City of Alexandria, Virginia

MEMORANDUM

SUBJECT: DSUP #2002-0048; MPA #2003-004; REZ #2002-005
QUAKER RIDGE, 3517-3551 DUKE ST.

A. Geo-technical Report- Quaker Village Retaining Wall:

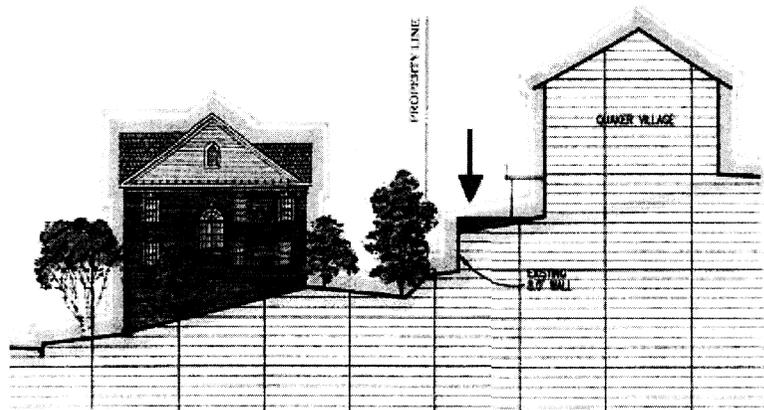
The adjoining Quaker Village residents have raised the possibility of providing a retaining wall on the northern property line of the Quaker Ridge development, or raising the height of the existing retaining wall on the Quaker Village property to provide increased screening for the proposed development. According to T&ES, a retaining wall is designed for a specific vertical and horizontal

loading capacity. In this case the City has no specific geo-technical testing data relating to the existing and/or proposed wall. However, it is generally problematic from a design standpoint to add height and fill. The applicant's engineer performed an analysis of the possibility of raising the height of the existing retaining wall. While there are areas of concern, based upon preliminary analysis by the developer, it appears that it may be possible to increase the height of the wall, with the feasibility of raising the height of the retaining wall requiring further engineering analysis and staff review prior to construction.

The second suggestion was the possibility of raising the height of the existing retaining wall on Quaker Village to provide level rear yards and additional screening for the Quaker Village townhouses as generally depicted below.

Current R-8 Zoning (9 Units)

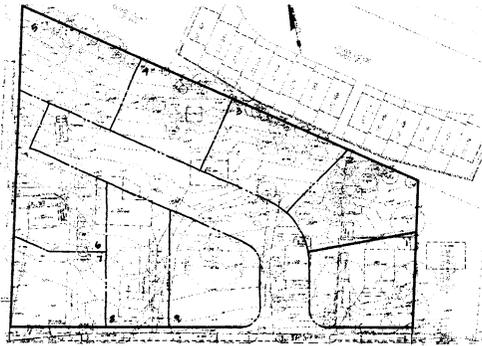
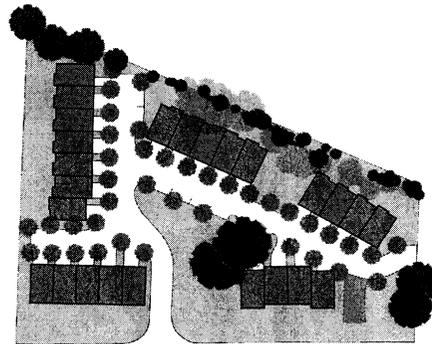
Based upon the minimum lot area requirements within the R-8/Single family zone, a maximum of 9 single family homes could be constructed on the subject property. One additional home could be constructed on the adjoining parcel located to the east of the applicant's assemblage under the R-8 zoning.

The Planning Commission and staff recommended a reduction in the number of units from 28 to 25, which reduces the overall density of the site from 11.24 units per acre to 10.04 units per acre. As a comparison, the density of Colonial Heights is 9.9 units per acre (44 units on 4.44 acres) and Quaker Village is 11.15 units per acre (55 units on 4.93 acres).

Existing Trees To Be Removed and Retained

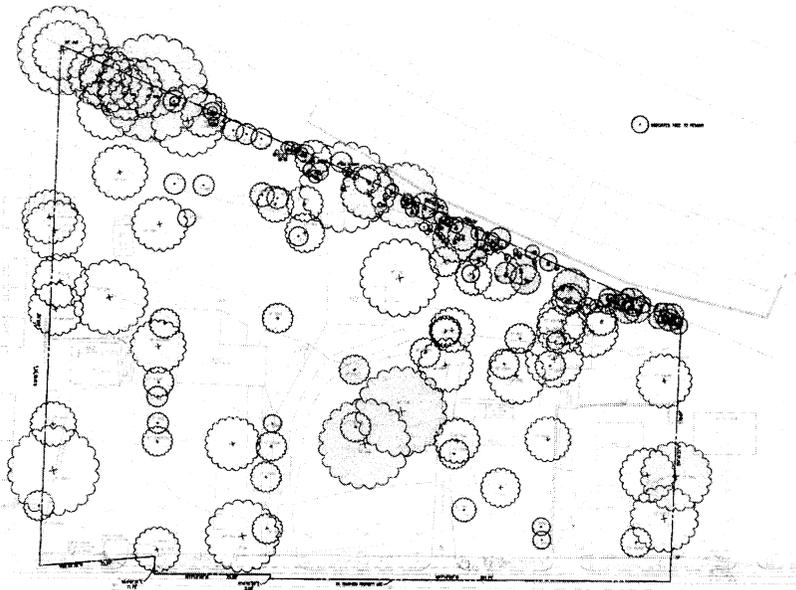
The applicant proposes to retain 83 trees in the buffer area along the northern portion of the site adjacent to Quaker Village. As depicted on the preliminary site plan, a total of 68 trees are proposed to be removed. The applicant proposes to plant 113 new trees of varying species and heights that range from 6'- 12'.

E. Parking:

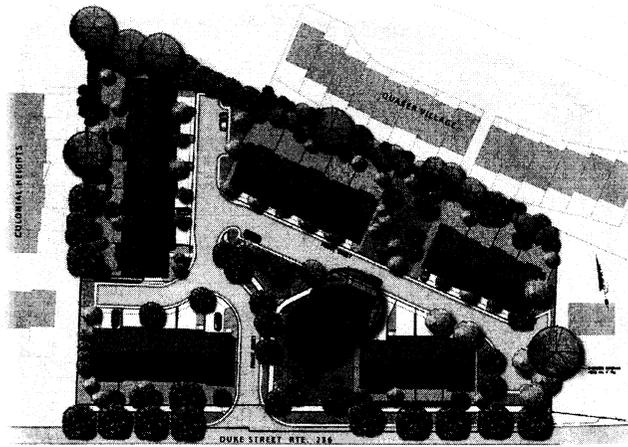
One of the issues that has been raised is the possibility of locating the units adjacent to Quaker Village approximately 10 ft. farther from Quaker Village by reducing the length of the driveways for these units as depicted below.

Locating the units approximately 10 ft. farther away from Quaker Village will enable an increased physical separation, and a larger buffer on the northern portion of the site adjacent to Quaker Village. Reducing the depth of the driveways for the 9 units adjacent to Quaker Village would result in the elimination of 18 visitor parking spaces in the driveways. The resulting number of visitor parking spaces would be 8 spaces that are shared and 24 spaces within the driveways for a total of 32 visitor parking spaces.

In order to increase the physical distance of the proposed townhomes from Quaker Village, staff supports shifting the row of units located adjacent to Quaker Village farther to the south, which will eliminate several parking spaces in front of the units, but will provide a greater separation and increase the buffer area. The development provides more parking spaces than required by the zoning ordinance and than exist at either Colonial Heights or Quaker Village. The provision of additional parking spaces is not needed because of the current amount of resident and visitor parking and would decrease the amount of open space and landscaping.
